## Product Change Notification / SYST-09WTKU988

ERRATA - PIC32MM0256GPM064 Family Silicon Errata and Data Sheet Clarification

## PIC32MM0256GPM064 Family Silicon Errata and Data Sheet Clarification

### 2. Module: Pin Diagrams: 48-Pin UQFN, TQFP

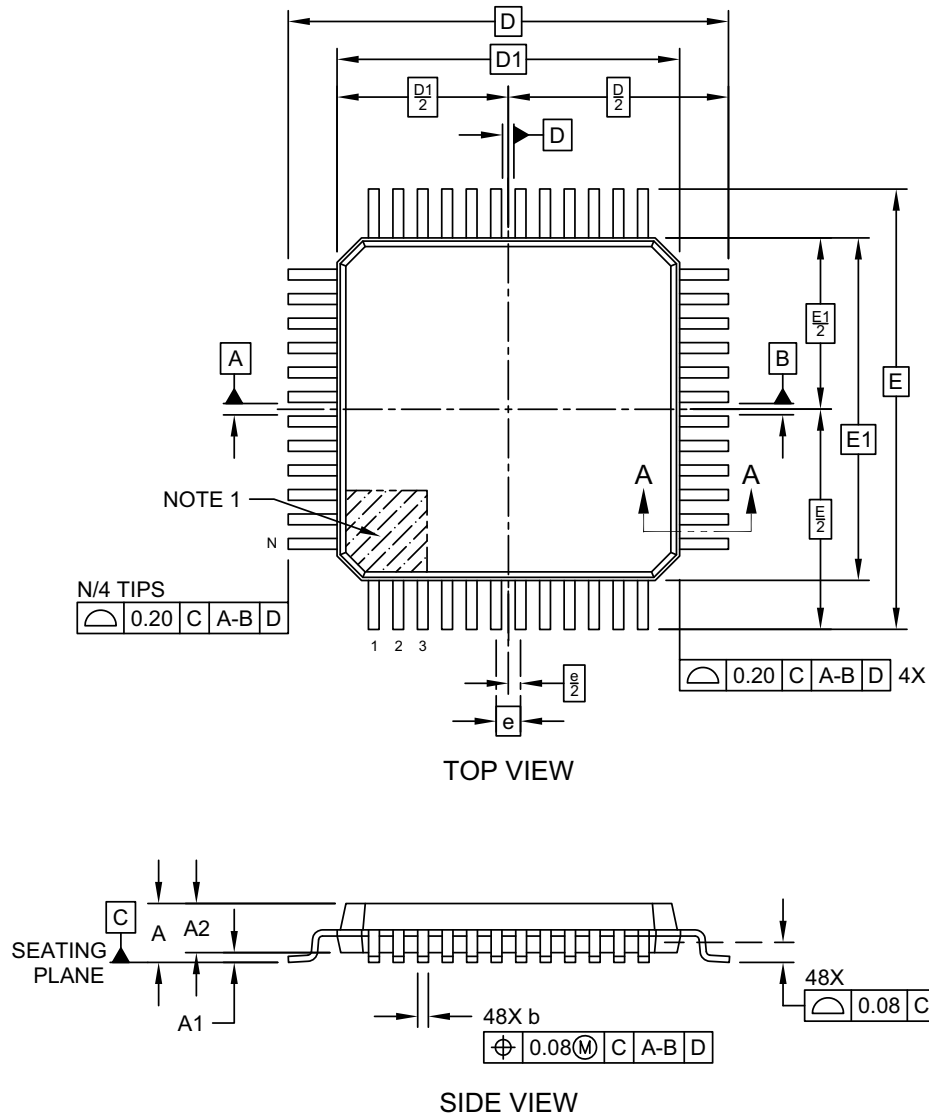
Note 3 is applicable for the 48-pin UQFN package only. The Thermal pad is not available on the 48-pin TQFP Package.

### 48-Lead Plastic Thin Quad Flatpack (Y8X) - 7x7x1.0 mm Body [TQFP]

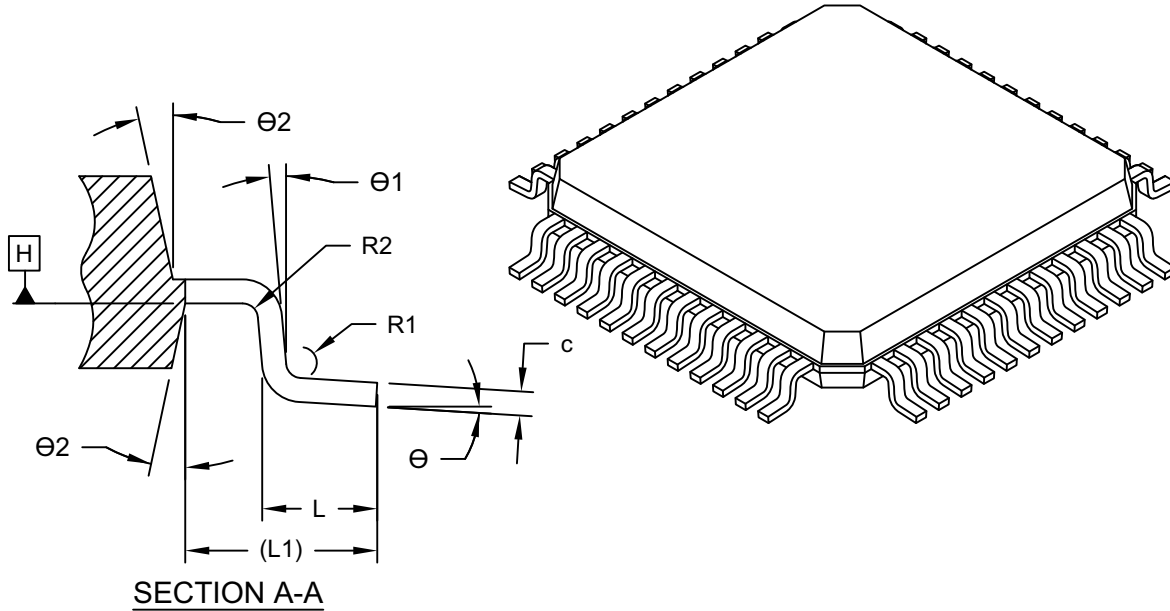
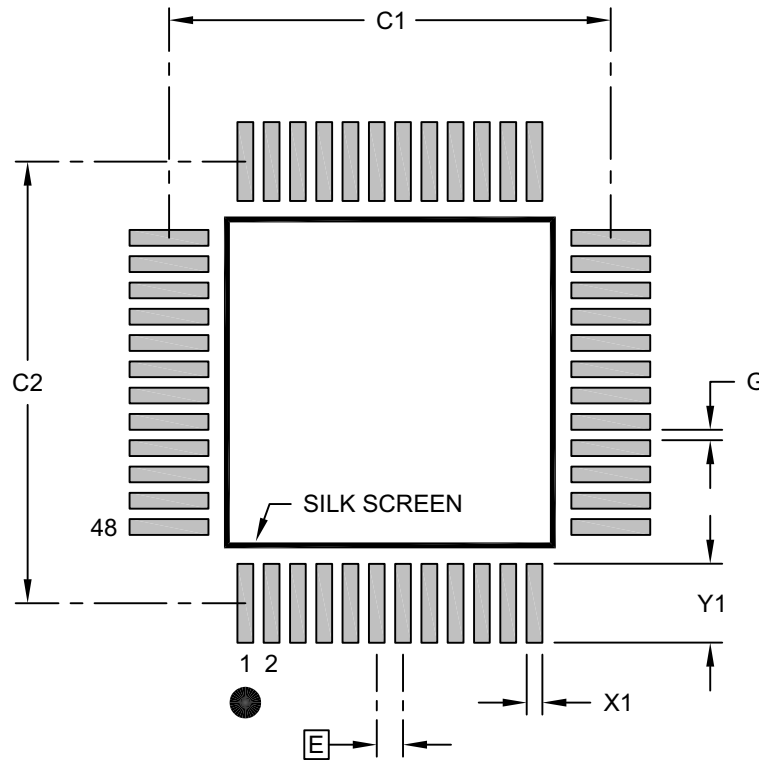
## 3. Module: Package Details/Drawing: 48-Pin TQFP

The following figure shows the updated package drawing for the 48-Pin TQFP Device:

## 4. Module: Pin Diagrams: 64-Pin QFN, TQFP

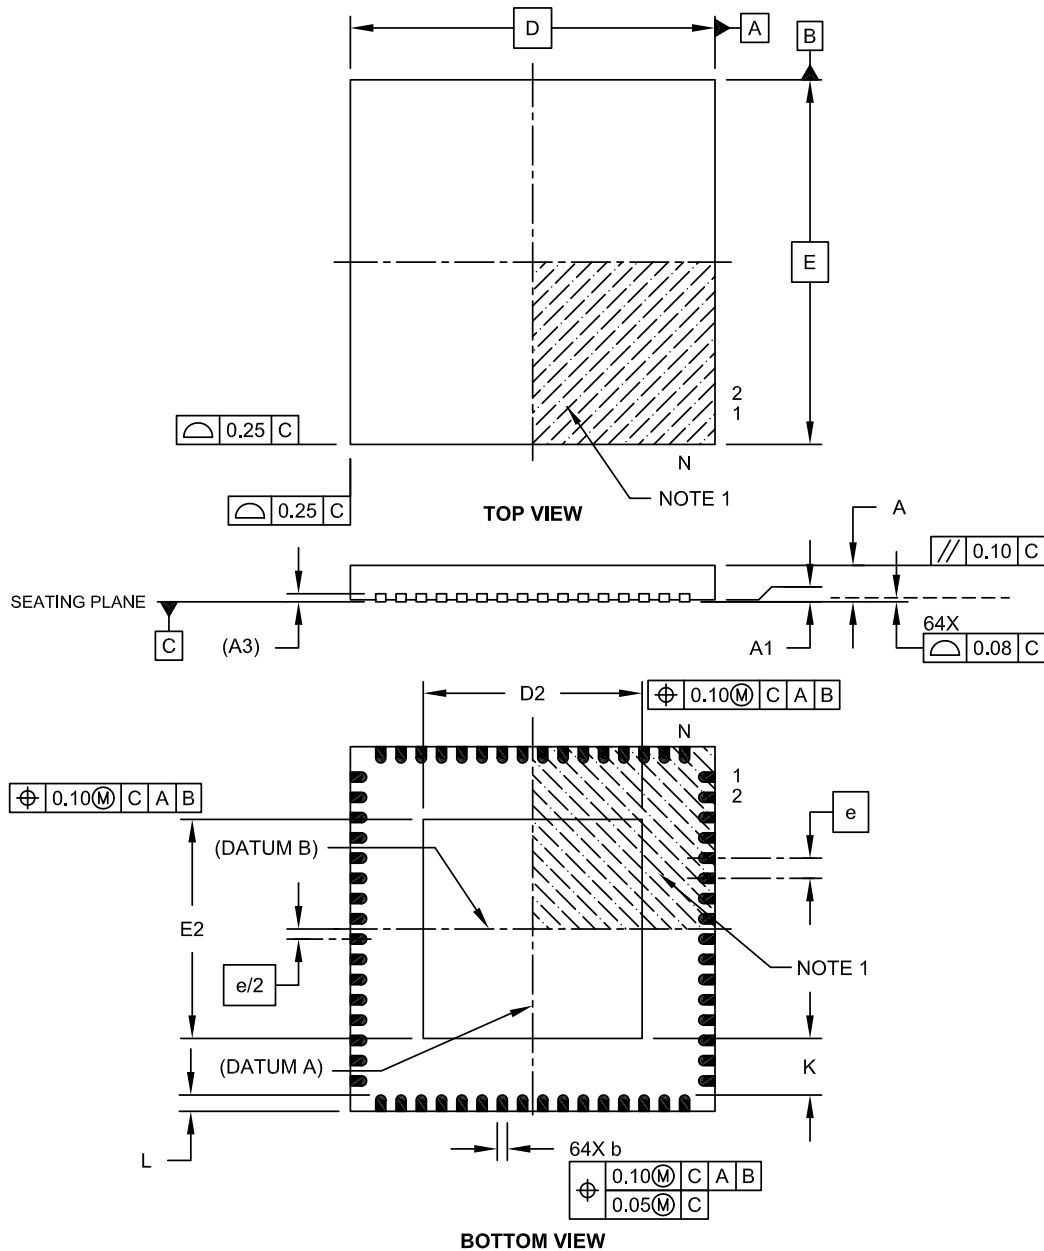
Note 3 is applicable for the 64-pin QFN package only. The Thermal pad is not available on the 64-Pin TQFP package.

### 64-Lead Plastic Quad Flat, No Lead Package (MR) – 9x9x0.9 mm Body with 5.40 x 5.40 Exposed Pad [QFN]

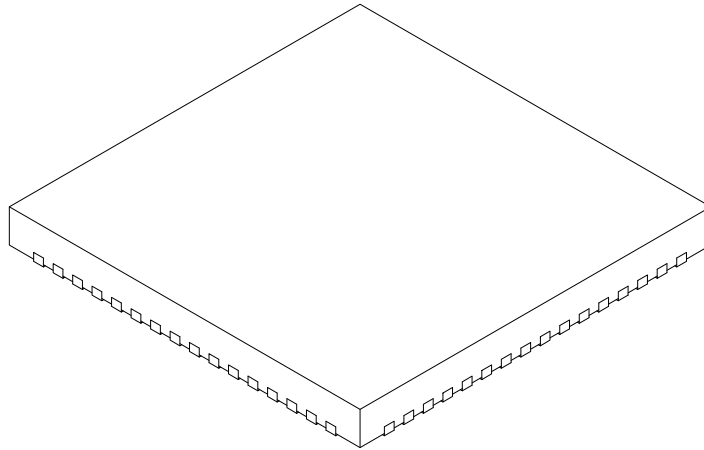
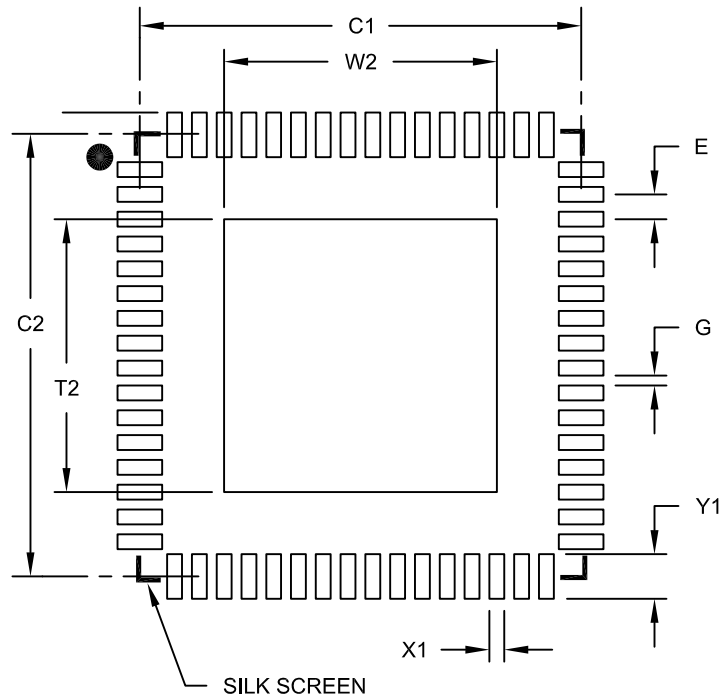
## 5. Module: Package Details/Drawing: 64-Pin QFN

The following figure shows the updated package drawing for the 64-Pin QFN device.
